ADDENDUM / ENVIRONMENTAL REEVALUATION

State Route 1 (Pacific Coast Highway) Drainage Rehabilitation and Bridge Replacement at Solstice Canyon Creek |
Project Addendum/Environmental Reevaluation to the Previously Approved Mitigated Negative Declaration (MND)/Finding
of No Significant Impact (FONSI)

19 November 2022

Figure 2. Proposed Pedestrian Undercrossing at Project Location No. 10 (Solstice Canyon Creek)

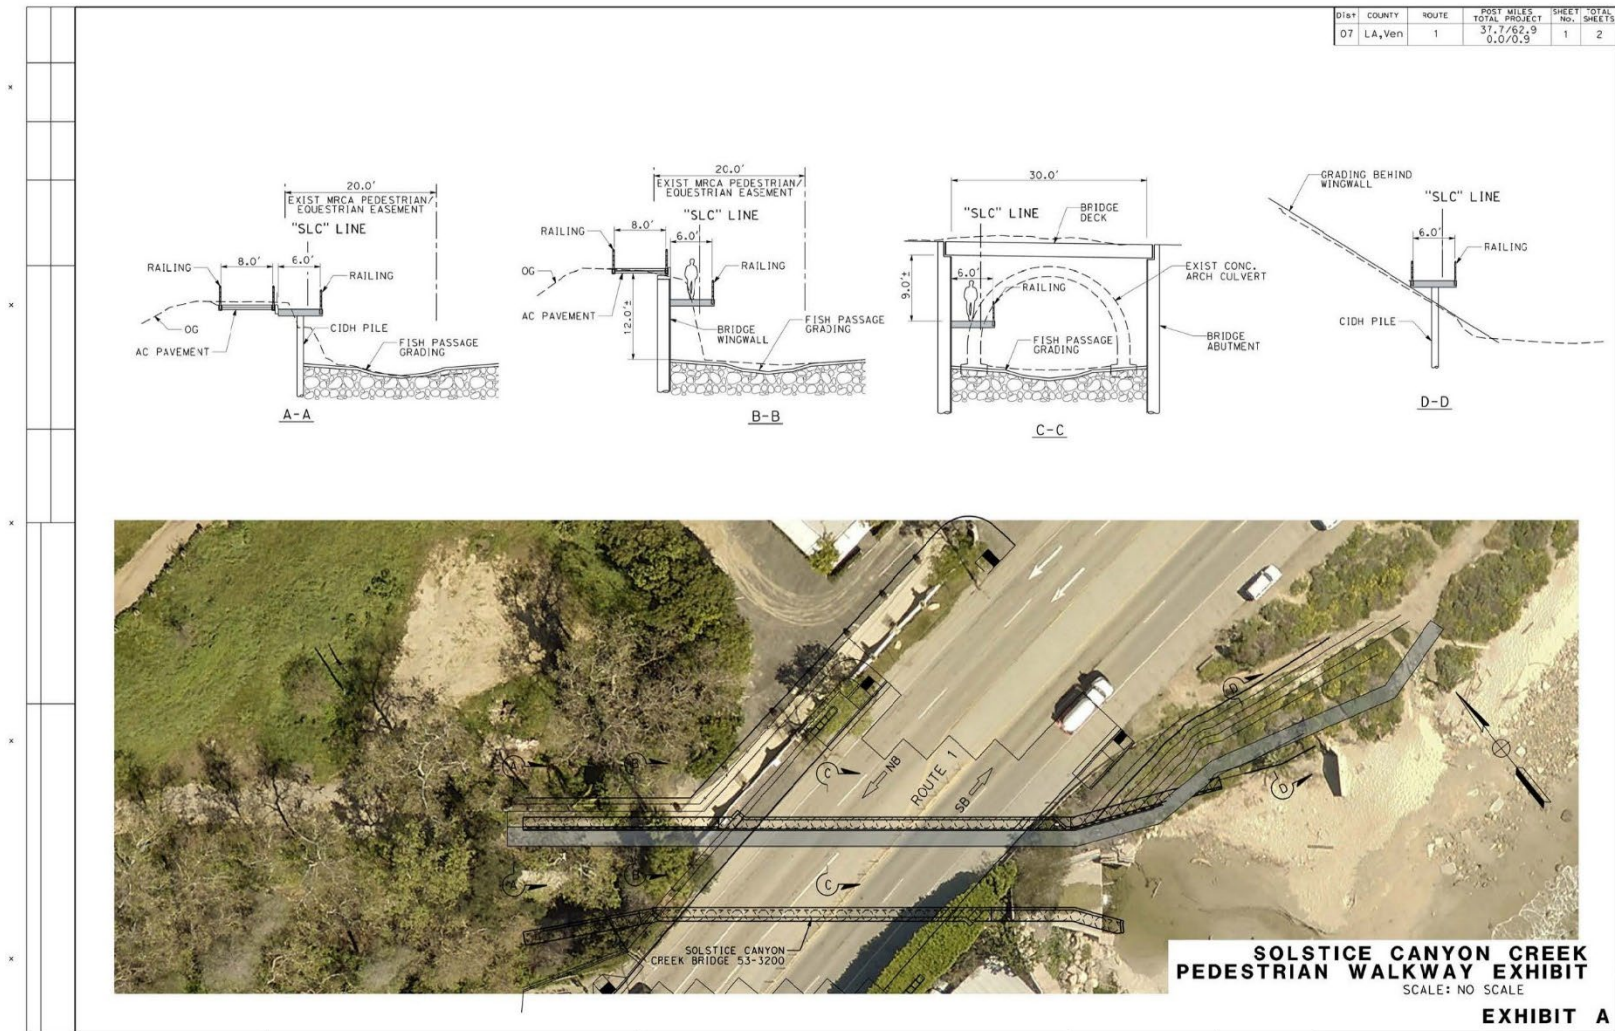
Addition of Pedestrian Undercrossing at Project Location No. 10 (Solstice Canyon Creek). In May of 2021, Caltrans Design began preliminary work on plans for a pedestrian undercrossing at Project Location No. 10 (Solstice Canyon Creek) in response to a request for public beach access from property owners adjacent to the project area. The property owners of the Calamigos Beach Club Restaurant at 26025 Pacific Coast Highway, Malibu, CA 90265 (which is part of the Calamigos Guest Ranch located at 327 Latigo Canyon Road, Malibu, CA 90265), requested that Caltrans consider providing walkway access underneath the newly proposed bridge structure at Solstice Canyon Creek from the restaurant to the beach as part of the proposed undertaking. While the intention of the request was to provide an undercrossing walkway to allow restaurant patrons access to the beach without having to cross the Pacific Coast Highway (PCH) roadway, its use was expanded to allow general public access (not specific to the adjacent property), which is more consistent with City of Malibu and California Coastal Commission goals of providing greater beach access to the general public. The following Figure 2 presents the general design of the proposed pedestrian undercrossing at Project Location No. 10 (Solstice Canyon Creek).

By July 2022, final design, and accompanying hydraulic analysis, and grading plans were achieved and plans/layouts specific to this proposed project location are appended to this addendum/reevaluation as Attachment A. In general, PCH runs north-to-south, but in the area of Project Location No. 10 (Solstice Canyon Creek), the roadway traverses the coastline in an east-to-west direction. The proposed pedestrian undercrossing is designed as a cantilevered concrete walkway so as not to impede hydraulic flow of the creek and would be attached to the eastern wing wall structure, perpendicular and beneath the newly proposed bridge.

Figure 3. Proposed Revegetation Area at Project Location No. 19 – Biological Mitigation

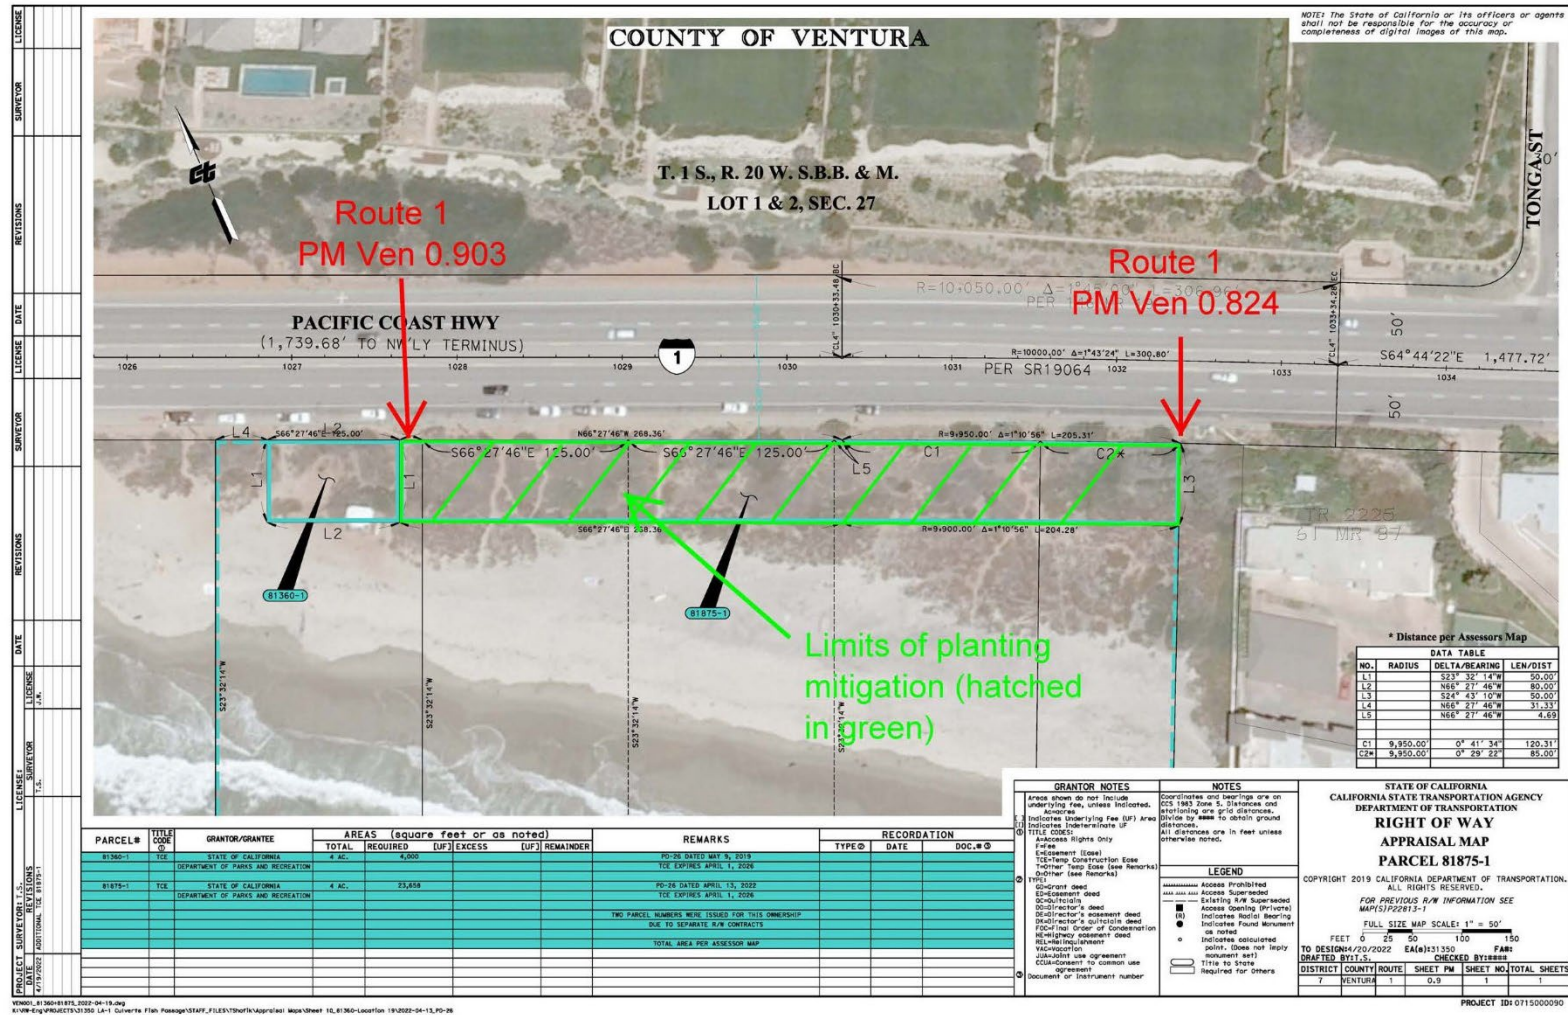
Supplemental/Proposed Revegetation at Project Location No. 19 – Biological Mitigation. As part of biological mitigation for the proposed undertaking, a total of 8 acres of revegetation with native plantings is proposed at Project Location No. 19 (VEN PM 0.92). Adjacent parcels 81360-1 and 81875-1 will be granted for these purposes by the State of California – Department of Parks and Recreation, located along PCH/SR-1 between VEN PM 0.903 and 0.824. Planting will be implemented south of the PCH roadway on the beach side and will consist of brush removal (by hand) and the manual excavation of several holes (12-inches-deep) to accommodate 1-gallon size native plantings. The general extent of these parcels is delineated in the following figure.
